# Immingham Green Energy Terminal

TR030008

Appendix J: Preliminary Environmental Information  
Report Addendum Report (PAR)

Second Statutory Consultation: Project Changes and Preliminary  
Environmental Information Report Addendum

## 6.2 Change No. 1: Site Boundary Amendments

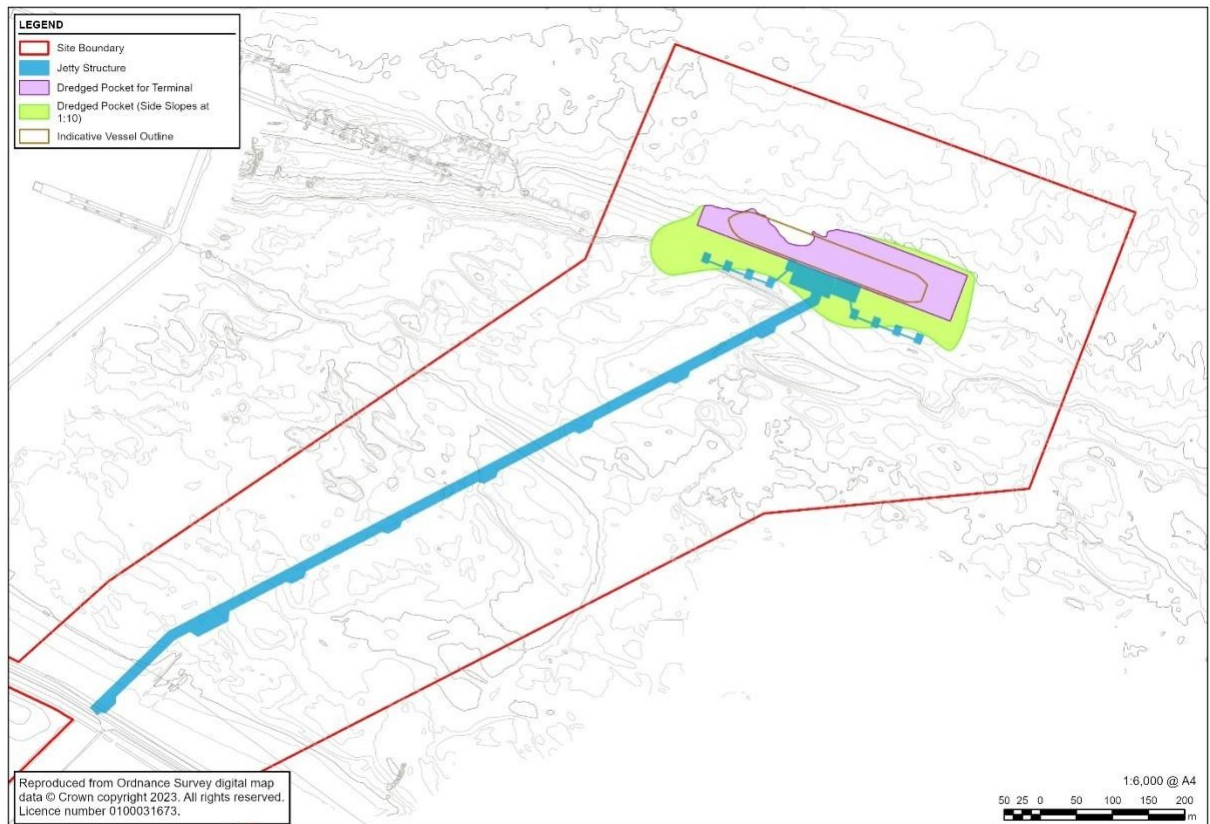
6.2.1 As a result of the design development for the Project, evaluation of consultation responses and further consideration of safety matters, the site boundary has been amended since the first Statutory Consultation. A total of six changes are proposed. These are shown on **Figure 6.1** (where the blue lines represent the changes to the site boundary) and are listed below:

1. Inclusion of four areas along Kings Road (see Change No. 8 below);
2. Removal of an area of land south of Queens Road which, following further design development, is now not required for the proposed pipeline corridor which will link the West and East Sites;
3. Inclusion of the southern part of the Long Strip woodland (see Change No. 7 below);
4. Inclusion of an additional section of Laporte Road (see Change No. 6 below);
5. Inclusion of an extended section of the sea wall (see Change No. 7 below);  
and
6. Re-orientation of the area of works in the marine area (removal of two large areas and inclusion of a third smaller area, see Change No. 2 below).

**Plate 6.2: Illustrative Pipe Rack and Jetty Access Road design (revised)**

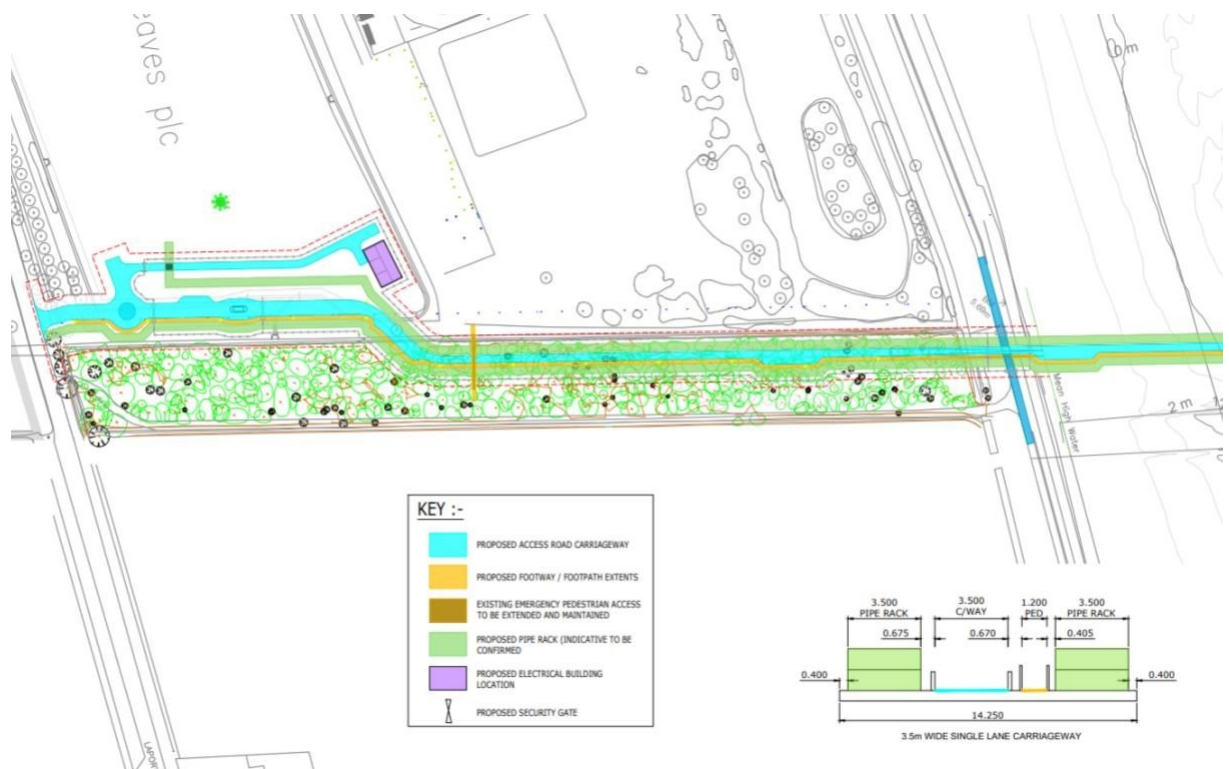
6.4.3 The design of the pipe-rack and the jetty access road including the electrical control building have been developed to avoid impacting the veteran tree by bringing the jetty access road along the western edge of the TPO. The western section of the jetty access road now runs within the East Site, rather than within the woodland, reducing the impact of the Project on the Long Strip woodland in this area.

**Plate 6.4: Speed Limit adjustments to Laporte Road**

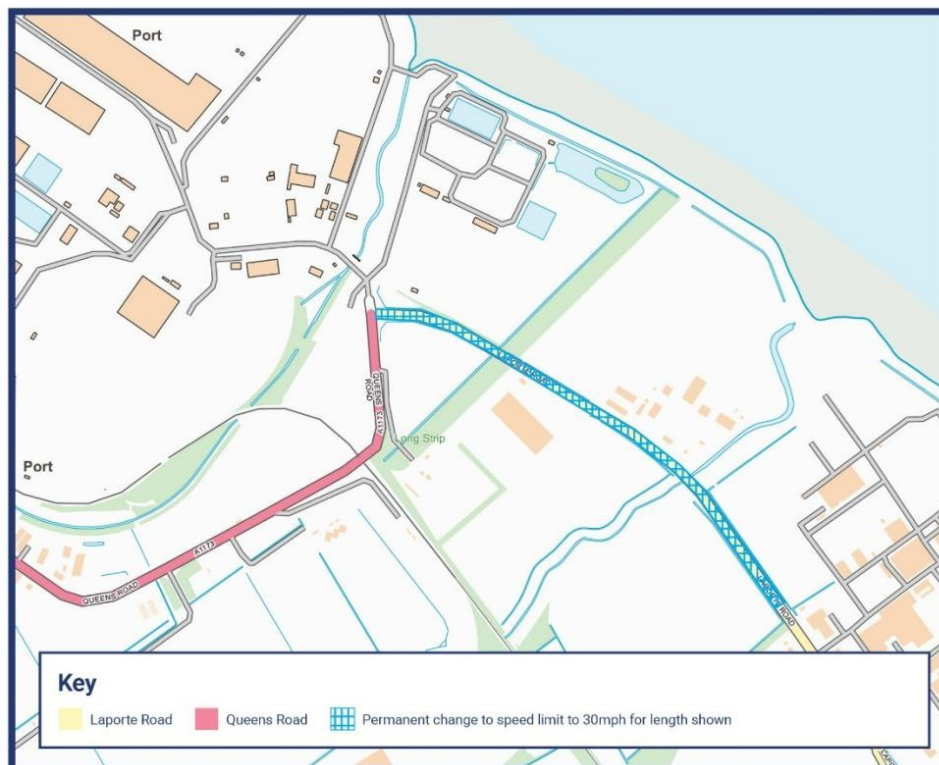
6.7.2 Since the first Statutory Consultation and to ensure the safety of road users a permanent reduction to the speed limit on Laporte Road has been determined to be necessary. A permanent 30mph speed limit is therefore proposed for the length of Laporte Road between the junction with Queens Road and the Tronox site entrance and this change is supported, in principle, by NELC. The length shown of Laporte Road to which these changes are applicable is shown in **Plate 6.4** below:

### Plate 6.5: Changes to Public Rights of Way and Public Access

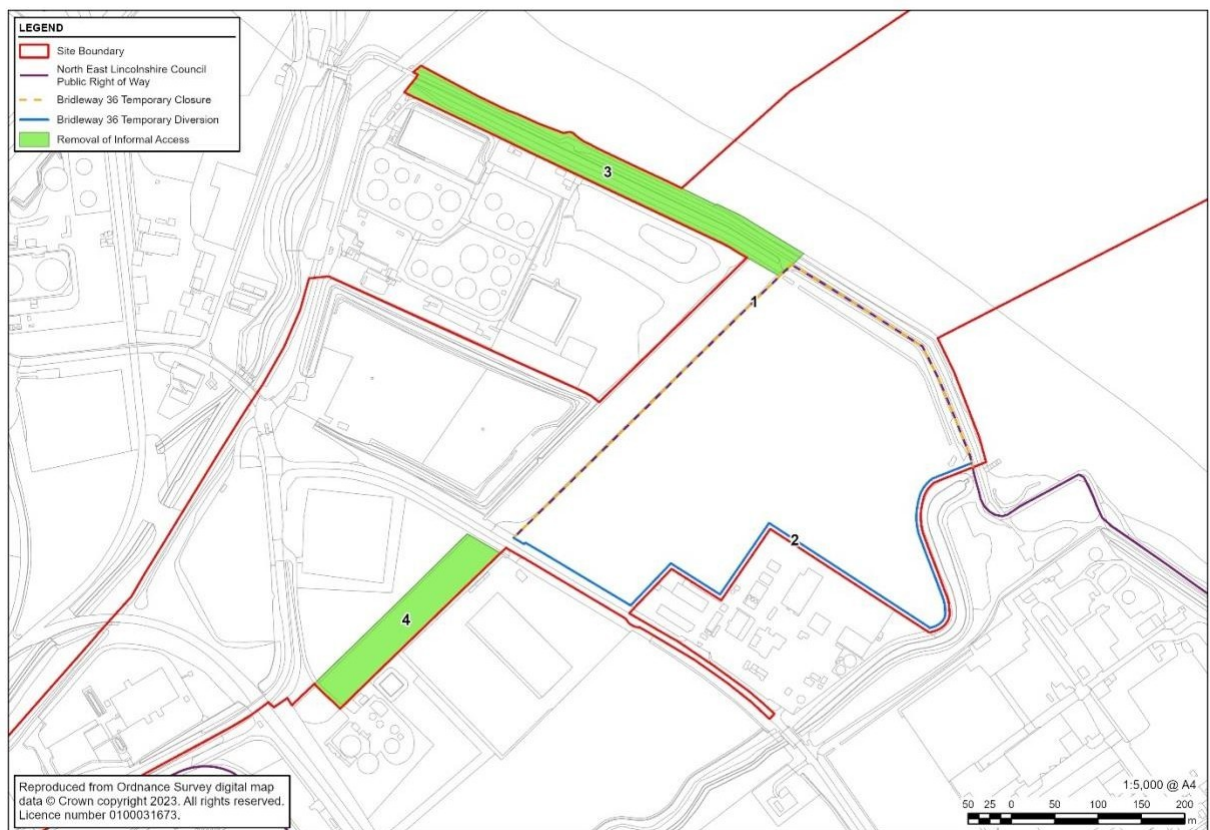
6.8.1 As explained at the first Statutory Consultation, the part of Public Bridleway Number 36 which runs from Laporte Road to the sea wall, along the east side of the Long Strip woodland, see 1 on **Plate 6.5**, would need to be closed along this alignment during the first phase of construction of the Project because of the use of the large arable field immediately to the east as the main temporary construction area. At the first Statutory Consultation it was explained that the Bridleway would be *either* temporarily closed or diverted.

6.8.2 Reflecting feedback received during the first Statutory Consultation, a decision has been taken to provide a temporary Bridleway diversion route (2 on Plate 6.5), along the north side of Laporte Road and around the eastern edge of the main temporary construction area to reconnect with the retained Bridleway, but further east on the sea wall than at present. Once the first phase of construction is completed (currently assumed to be a 2.5 year period) and the temporary construction area has been removed, the Bridleway would be re-instated on its current alignment and the temporary diversion would be closed.
